Exhibit A1
Planning Division Staff Report
Class 3 Sign Permit and Wall Mural for ParkWorks

Hearing Date:	July 28, 2025
Date of Report:	July 21, 2025
Application No.:	DB25-0002 Class 3 Sign Permit and Wall Mural Review
Request/Summary:	The Development Review Board is being asked to review a Class 3 Sign Permit, Waiver, and Site Design Review for ParkWorks
Location:	26600 SW Parkway Avenue. The property described as Tax Lot 00511, Section 12, Township 3 South, Range 1 West, Willamette Meridian, City of Wilsonville, Clackamas County, Oregon.
Owner:	SKB-Parkworks LLC (Matt Moravi)
Applicant:	Danny Riordan, Tube Art Displays, Inc.
Authorized Representative:	Scott Caulfield, Scott Caulfield Enterprises
Comprehensive Plan Designation:	Industrial
Zone Map Classification:	PDI (Planned Development Industrial)
Staff Reviewer:	Georgia McAlister, Associate Planner

Staff Recommendation: **Approve with Conditions** the requested Class 3 Sign Permit, Waiver, and Site Design Review.

Proposed 355 sq. ft. sign

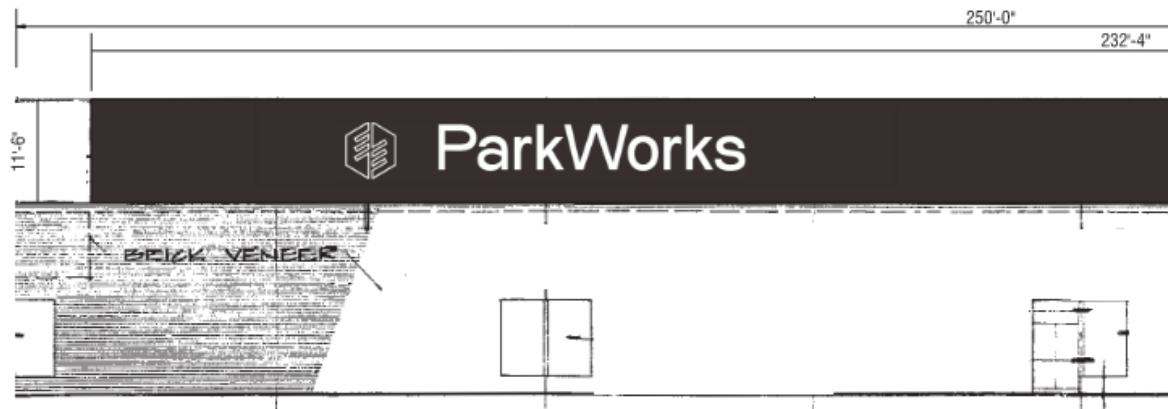
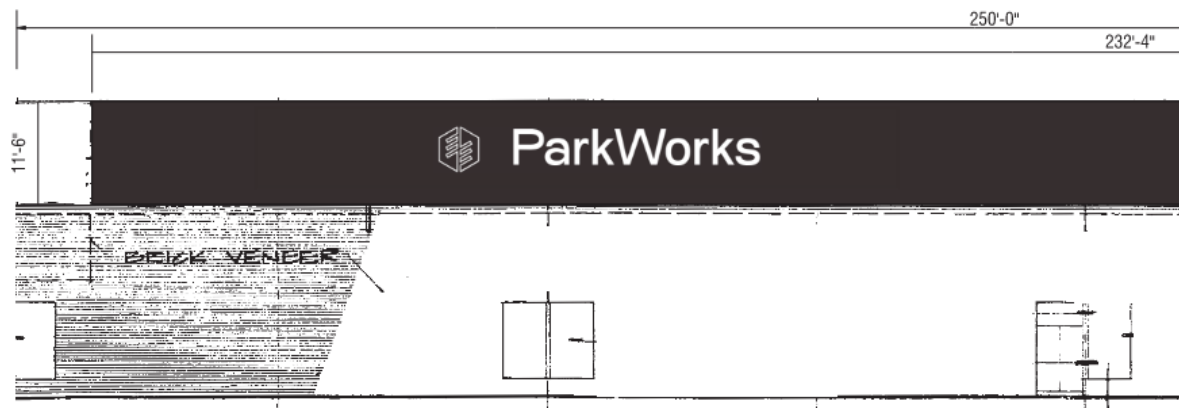
The three images above demonstrate how the relationship between the size of the sign and the architectural feature in which they are placed changes the visual impact of the sign. In the first image the 355 sq. ft. sign dominates the parapet and does not appear to be balanced. Whether there is sufficient definable space is questionable as the sign appears to be “pushing” against the upper edge of the parapet.

The second image illustrates the staff’s recommendation to limit the extent of the waiver to allow for a maximum of 200 sq. ft. The 200 sq. ft. sign balances positive and negative space appropriately. There is noticeable definable space between the sign and the edges of the parapet. The sign does not appear to dominate the architectural feature but instead it adds interest to an otherwise plain façade enhancing the design.

The third image depicts the sign at 132 sq. ft., the maximum allowed sign area based on the length of the façade. The smaller sign does not fill the parapet as well as the 200 sq. ft. sign.

While there is definable space, an argument can be made that too much is provided throwing off the balance between the positive and negative space.

PDA 1.	<u>Ongoing:</u> The approved sign shall not exceed 200 sq. ft. and be installed in a manner substantially similar to the sign approved by the DRB and stamped plans approved by the Planning Division.
PDA 2.	<u>Prior to Installation:</u> The applicant shall submit a Class 1 Sign permit including drawings demonstrating compliance with the DRB approval

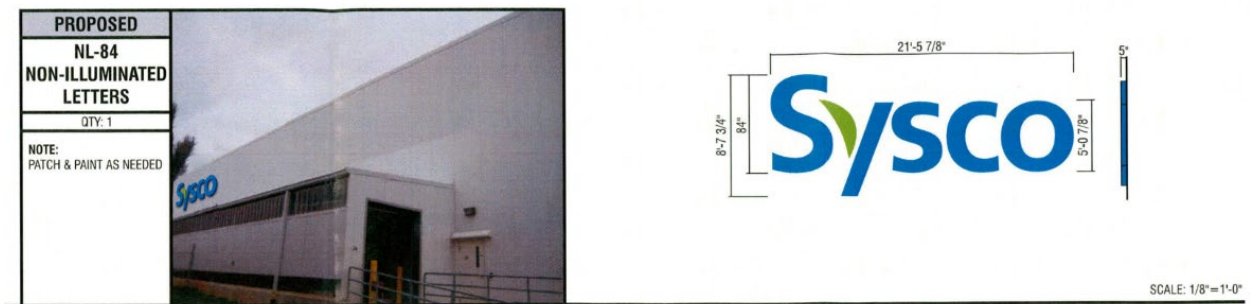
The most recent approval of a waiver request for an increase to wall sign allowance, DB20-0034, included one 134 sq. ft. wall sign for I&E Construction, located south of the subject property, on Parkway Avenue. The sign is located on the west façade of the building which faces the I-5 Freeway. The west façade's sign allowance is 64 sq. ft. with the waiver allowing for an additional 70 sq. ft. of signage. The 134 sq. ft. sign is integrated into the building's architecture, centered within a large aluminum mesh screen. The large mesh screen is an architectural feature that serves multiple purposes including sound dampening from the highway, providing shade and protection from the sun, and architectural interest. The size of the sign is appropriately sized for the architectural feature it is placed within. There is clear definable space on all sides of the sign with 5 ft of vertical space between the top of the sign and the edge of the mesh screen, 4.5 ft of vertical space between the bottom of the sign and edge of the mesh screen, and 10.5 ft of horizontal space between the sign and the north and south edges of the mesh screen. The mesh screen is not included in the sign area calculations due to the fact it is an architectural feature. A rendering of the west façade, including the 134 sq. ft. sign, is included below:

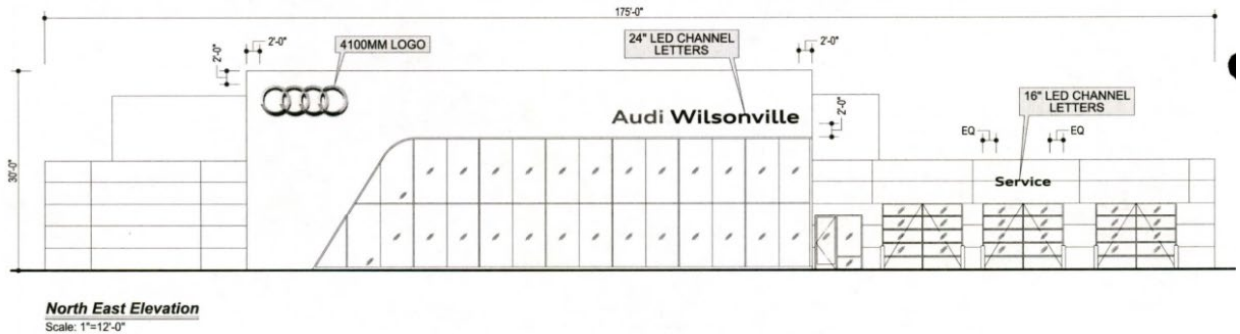
The Audi dealership located to the west of ParkWorks, across I-5, at 26750 SW 95th Avenue is again a comparable example of wall signs in the area. Similar to the ParkWorks development, the Audi dealership's northwest facade is visible but setback from I-5 and the parallel street, Boones Ferry Road. The northwest façade includes two wall signs totaling approximately 200 sq. ft. The two signs are placed thoughtfully in relationship to the building architecture with appropriate space between the edges of the façade and glazing elements, creating a clean look with a definable space specific to the sign. Since the 200 sq. ft. allowance is broken up between the two signs the appearance of the signage does not overly dominate the façade. While there is only 2ft between the signs and the edges of the architectural features they are placed within, the simple design of the façade which prevents the signs from feeling cramped or inappropriately placed. While the edge

of the Audi logo is framed by the roof line and south edge of the façade on two sides, the other two sides are unrestricted, creating a feeling of openness. Similarly, the “Audi Wilsonville” portion of the sign is framed by the glazing and north façade on two sides, while the other edges of the sign remain open. See the design and location of the signs as included as a part of Audi’s sign adjustments, AR10-0017, below:

Proposed 355 sq. ft. sign

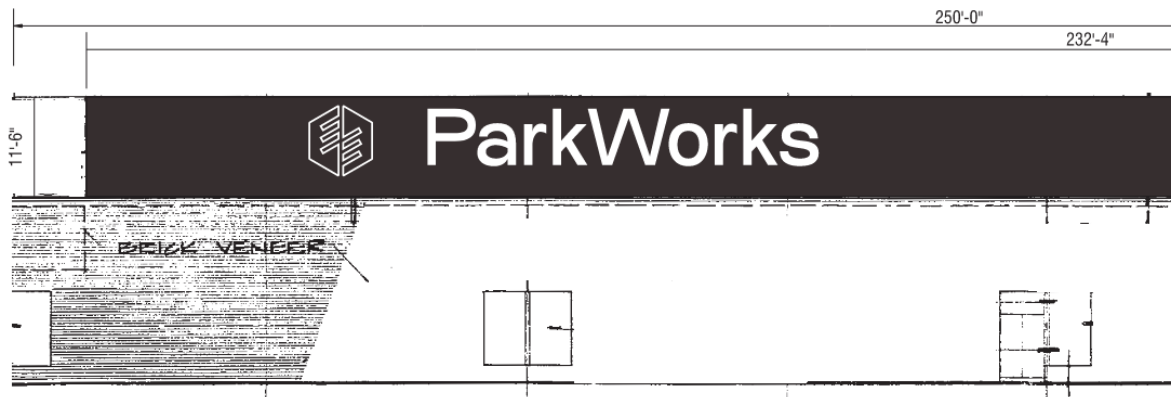
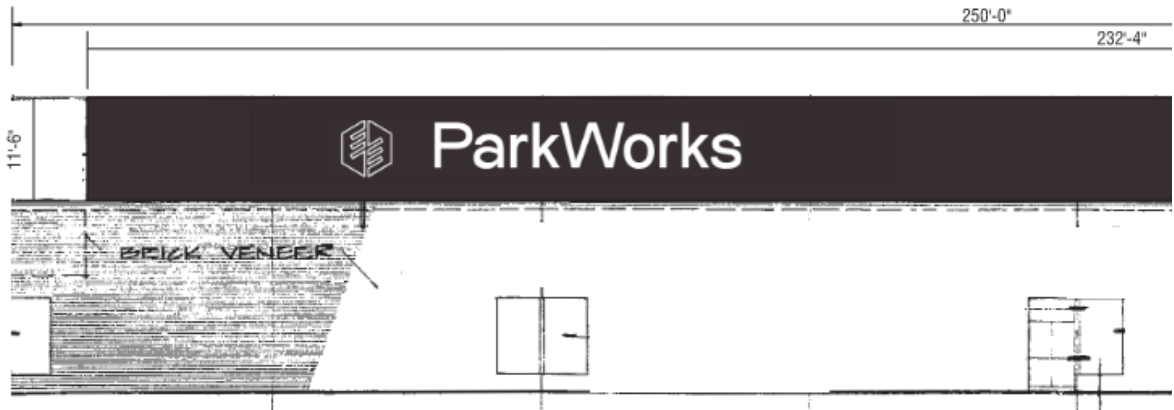
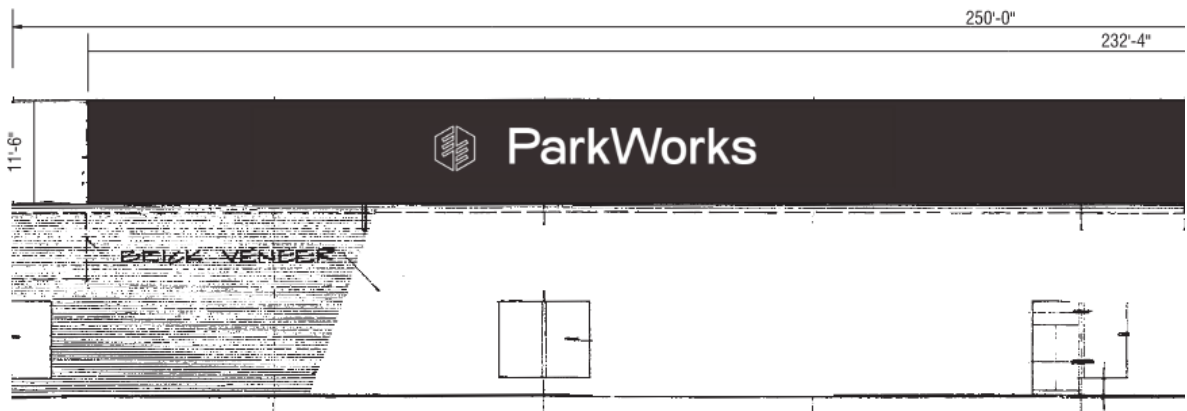
The three images above demonstrate how the relationship between the size of the sign and the architectural feature in which they are placed changes the visual impact of the sign. In the first image the 355 sq. ft. sign dominates the parapet and does not appear to be balanced. Whether there is sufficient definable space is questionable as the sign appears to be “pushing” against the upper edge of the parapet creating a constricted feeling.

The second image illustrates the staff’s recommendation to limit the extent of the waiver to allow for a maximum of 200 sq. ft. The 200 sq. ft. sign balances positive and negative space appropriately. There is noticeable definable space between the sign and the edges of the parapet. The sign does not appear to dominate the architectural feature but instead it adds interest to an otherwise plain façade enhancing the design.

The third image depicts the sign at 132 sq. ft., the maximum allowed sign area based on the length of the façade. The smaller sign does not fill the parapet as well as the 200 sq.

ft. sign. While there is definable space, an argument can be made that too much is provided throwing off the balance between the positive and negative space.
